# Work Order ID 85829

Item Name: Crosstube Turning Detail

<b>DART AEROSPACE LTD</b>		<b>Work Order:</b>	85829
<b>Description:</b> Crosstube Assembly (205/212/412 High Fwd)		<b>Part Number:</b>	D212-664-141
<b>Inspection Dwg:</b> D212-664-141 <b>Rev:</b> D		Page 1 of 2

DRAWING NO. D212-664-141	TITLE XTUBE ASSY (205/212/412 HI FWD)	REV. D	<b>DART AEROSPACE LTD ENGINEERING ORDER</b>		D.E.O. NO. D212-664-141-D-1	SHEET NO. SHEET 1 OF 2	SCALE NTS
DRAWN	CHECKED	MFG. APPR.	APPROVED	DE APPR.			
DATE 11.04.07	DATE 11.04.11	DATE 11.04.12	DATE 11/04/12	DATE 11.04.12

**D212-664-141/-141B  
ASSEMBLY DETAIL**

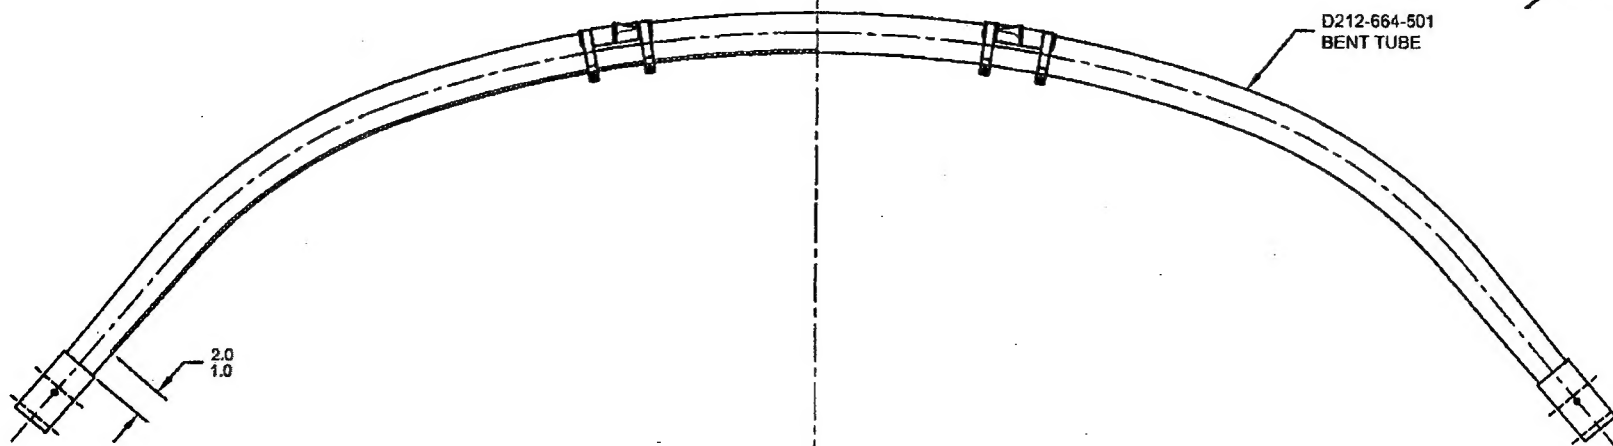
**PURPOSE:**

ADD AN INSPECTION WINDOW TO UNDERSIDE OF CROSSTUBE.

NOTES 2 OF SHEET 1 IS AMENDED AS FOLLOWS:

- 2) FINISH: CHEMICAL CONVERSION COAT PER DART QSI 005 4.1  
PRIME INSIDE AND OUTSIDE PER DART QSI 005 4.2  
MASK UNDERSIDE OF CROSSTUBE AS SHOWN (HATCHED AREA) AND  
PAINT OUTSIDE PER DART QSI 005 4.2  
REMOVE MASKING AND APPLY CLEAR COAT

MASK AREA PRIOR TO PAINTING,  
REMOVE MASKING AFTER PAINT  
AND APPLY CLEAR COAT
